December 11, 2023

RE: U.S. Bureau of Reclamation's Revised Draft Supplemental Environmental Impact Statement for Near-term Colorado River Operations dated October 2023 (88 Fed. Reg. 73840)

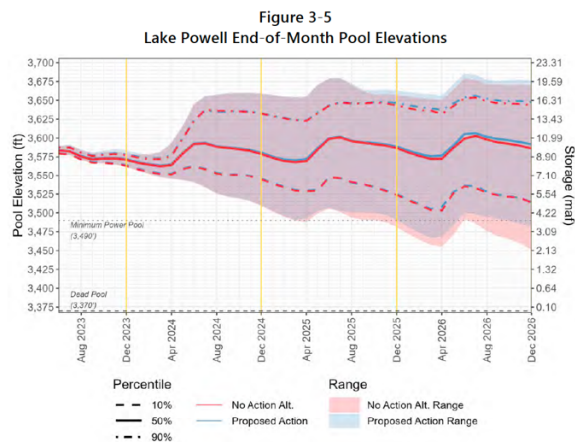
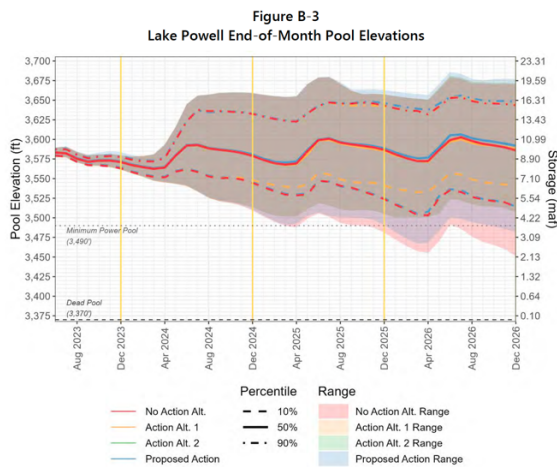
Specifically for Lake Powell, Reclamation found 8 percent of traces reaching critical elevations through 2026 for the No Action Alternative and 4 percent of traces for the Lower Basin Proposal.²⁹ However, what is particularly interesting is Reclamation’s analysis in Appendix B of the Revised Draft SEIS, which looks at not just the No Action and Lower Basin Plan, but also includes an analysis of Reclamation’s Alternatives 1 and 2 under the June 2023 hydrology. The gray cloud in Figure B-3, *Lake Powell End-of-Month Pool Elevations* (left), shows that the amount of conservation in Alternatives 1 and 2 provides a benefit to reservoir elevations beyond the selected alternatives that is not insignificant. A side-by-side comparison of Lake Powell End-of-Month Pool Elevations modeled in the Revised Draft SEIS are shown in **Figure B-3** (left) and **Figure 3-5** (right) below:

It is clear from these graphs that better outcomes, at least for Lake Powell, occur under Alternatives 1 and 2. Appendix B of the Revised Draft SEIS³⁰ provides

In **Figure B-3**, the cloud extents, or full ranges of modeled Lake Powell elevations, are similar for all alternatives at the high end and median. The lower bound of the No Action Alternative and Proposed Action cloud drops to 3,500 feet in 2025 and decreases to a minimum of 3,451 feet and 3,467 feet in 2026, respectively. The lower bound of the clouds for Action Alternatives 1 and 2 does not drop below 3,490 feet; this is because these alternatives include a provision to protect a Lake Powell elevation of 3,500 feet.

The question remains why the cloud for the Proposed Action in **Figure 3-5** falls below the minimum power pool critical elevation in 2025 and 2026 for certain traces despite the protection mechanism of 3,500 feet being included in that Alternative. We assume that this occurs because of the commitment to maintain the minimum flows required in LTEMP, but a clearer explanation of this is needed in the Revised Draft SEIS. If this is the case, then the need for additional conservation to be added to the alternatives or another policy revision may be needed to protect against Lake Powell reaching minimum power pool and meeting the purpose and need of the action.

Figure 3-8 from the Revised Draft SEIS⁵⁶ (left) and Figure B-8 from Appendix B to the Revised Draft SEIS⁵⁷ (right) show modeled reservoir elevations at Lake Mead.

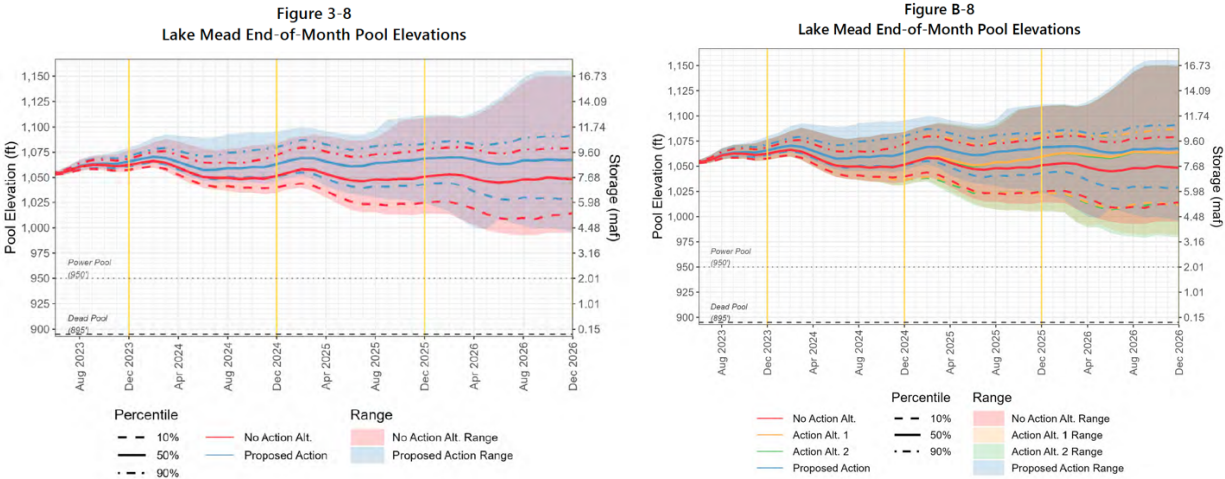
Figure 3-8 shows that Lake Mead elevations stay well above (nearly 50 feet) above minimum power pool (elevation 950 feet) under the No Action and Proposed Action. Figure B-8 shows the clouds for traces for Alternatives 1 and 2 reaching lower elevations approaching elevation 975 feet in 2026. “Action Alternatives 1 and 2 have the lowest modeled elevations at 982 feet and 980 feet, respectively, while the No Action Alternative and Proposed Action end 2026 approximately 13 to 16 feet higher at around 995 feet and 996 feet, respectively.”⁵⁸ However, it should be noted that 980 feet (the lowest elevation reached) is still 30 feet over minimum power pool at Lake Mead. The buffer at Lake Powell (3,500 feet) is only 10 feet above the minimum power pool elevation of 3,490 feet. If this comparison were apples to apples, we’d be looking at a Lake Powell protection level of 3,515 feet to Lake Mead’s 1,000 feet or Lake Powell 3,500 feet to Lake Meads 950 feet. The reason for this difference is not stated or explained in the Revised Draft SEIS.

Figure B-9 in Reclamation’s analysis uses Lake Mead elevation 1,020 feet to analyze percentages of traces below critical reservoir elevations.⁵⁹ Reclamation notes that “[a]n elevation of 1,020 feet was

Figure 3-35
Box Plots Showing the Number of Days with an Average Glen Canyon Dam Release Temperature over 16°C (60.8°F) for All CRMMS Traces and Each Alternative for Operating Years 2023–2026*

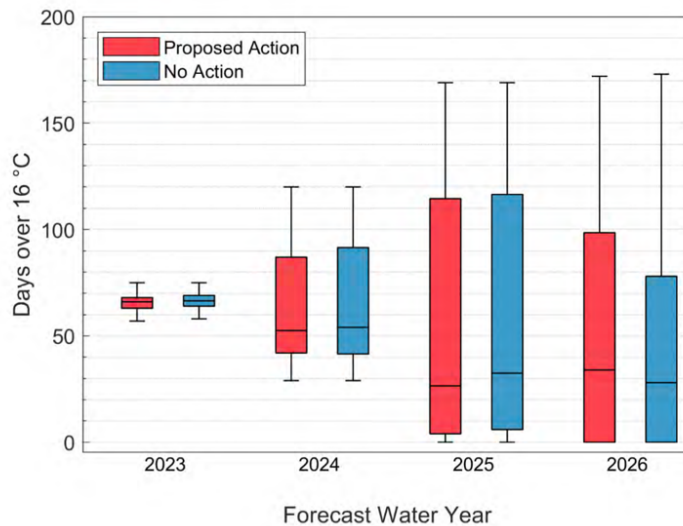
Reservoir elevations and where water is released (through the penstocks or the river outlet works) is “a key determinant” of release temperatures from Glen Canyon Dam.⁸² Reclamation’s modeling of the selected alternatives indicates that at the lower end of the modeled traces, Lake Powell could fall below minimum power pool (elevation 3,490 feet) as soon as 2025 and those reservoir elevations may hover around that “protection level” for the remainder of the interim period.⁸³ **Figure 3-35** shows the number of days with average release temperatures over 16 degrees C under the selected alternatives.

Given that smallmouth bass are already reproducing in Marble and Grand Canyons, these temperatures will further exacerbate the likelihood that the establishment will continue. Without
